UNITED STATES PATENT AND TRADEMARK OFFICE

APPLICATION NO.	FILING DATE	FIRST NAMED INVENTOR	ATTORNEY DOCKET NO.	CONFIRMATION NO.	
10/768,893	02/02/2004	Linda M. Smith	RST327	7296	
7590	08/15/2005		EXAMINER		
Sean A. Kaufhold		HWU, DAVIS D			
P.O. Box 131447		ART UNIT		PAPER NUMBER	
Carlsbad, CA 92013		3752

Office Action Summary	Application No.	Applicant(s)
	10/768,893	SMITH, LINDA M.
	Examiner	Art Unit
	Davis D. Hwu	3752

DETAILED ACTION***Claim Rejections - 35 USC § 103***

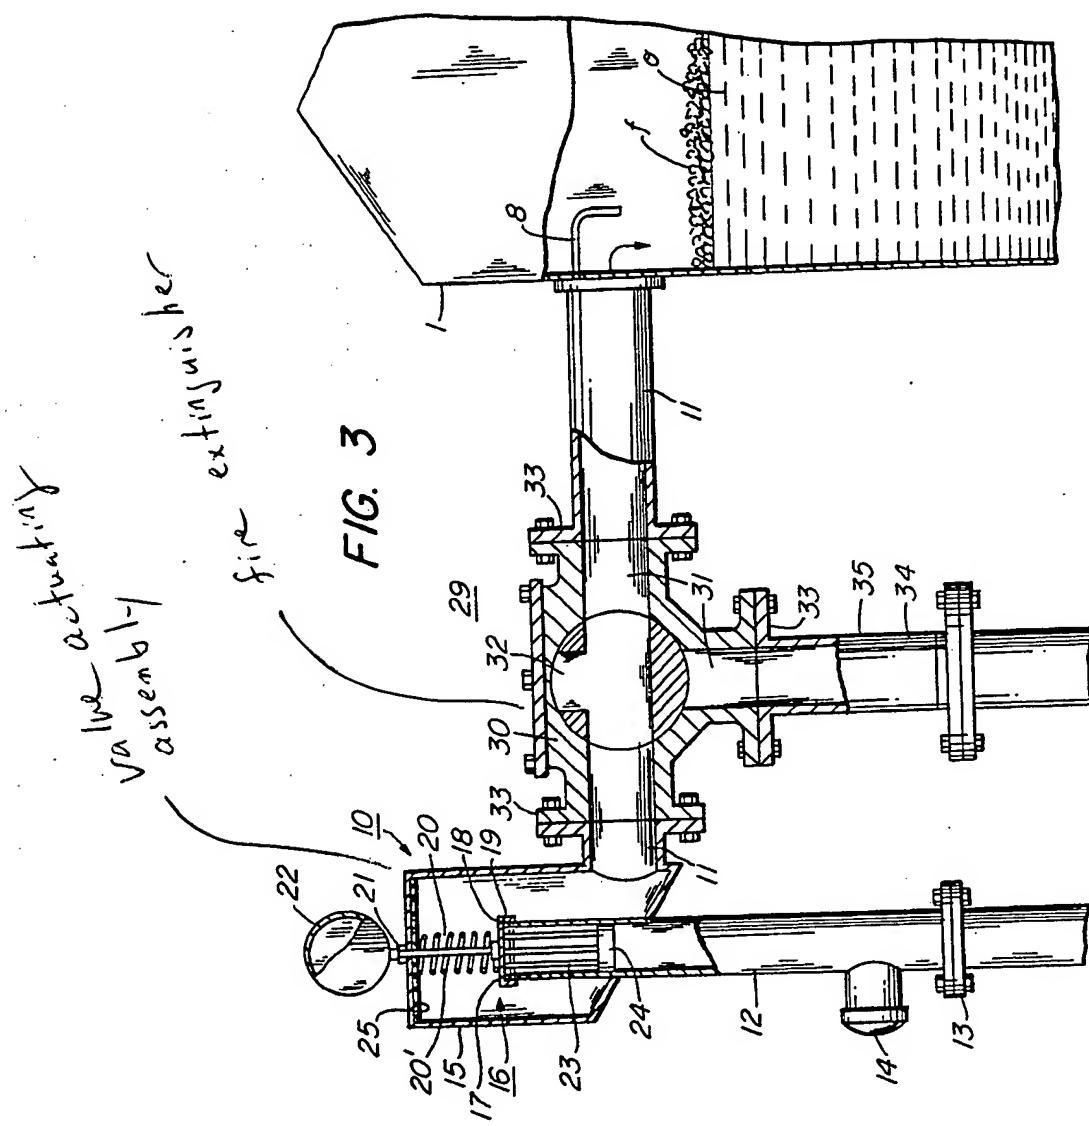
2. Claim 1 is rejected under 35 U.S.C. 103(a) as being unpatentable over Akatsu in view of Baron et al.

Akatsu discloses a fire extinguishing actuating and container combination device, the device being adapted for removably coupling to a fire extinguisher, the device comprising a container 1 as recited, a mounting being attached to an outer surface of the peripheral wall for mounting the fire extinguisher to the container, and a valve actuating assembly removably coupled the extinguisher (see Figure 3 attached herein).

Baron et al. teach a fire extinguishing system of a storage container in which the system comprises heat and smoke sensors which activate the fire extinguishing system. It would have been obvious to one having ordinary skill in the art at the time the invention was made to have modified the device of Akatsu by incorporating smoke and/or heat sensors in order to provide automatic operation of the fire extinguishing system under fire hazard conditions. It would also have been obvious to one having ordinary skill at the time the invention was made to have modified the device of Akatsu by removably mounting the fire extinguisher and the valve actuating assembly directly to the container 1 in order to be able to conveniently remove the fire extinguisher from the container if

necessary and since Akatsu already discloses that both the valve actuating assembly and the fire extinguisher are removably mounted within the device.
